Access Compliance Report Public Rights-of-Way (Curb Ramps)

Main Street: CHRISTY_LN Cross Street: TIGERTAIL_DR Location: SW

ADA ID: RPRK211207130910 Ramp Type: Type 1 - Perpendicular Diagonal Initial Pass/Fail: Pass Overall Compliance: No Severity Score: 0

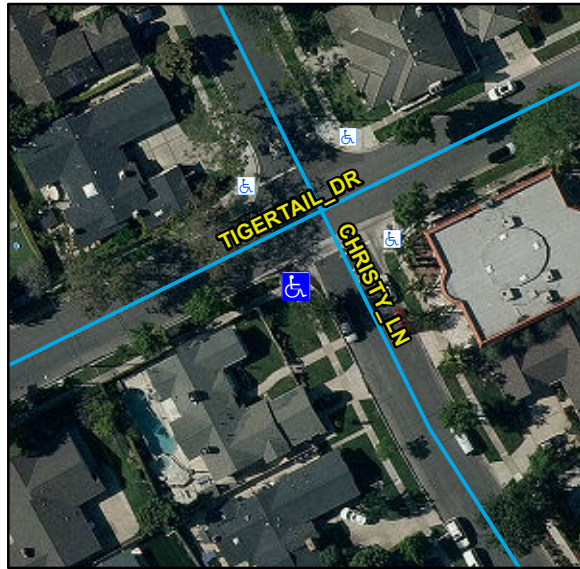
R304.5.3, STD 1115

Remove & Replace Landing.
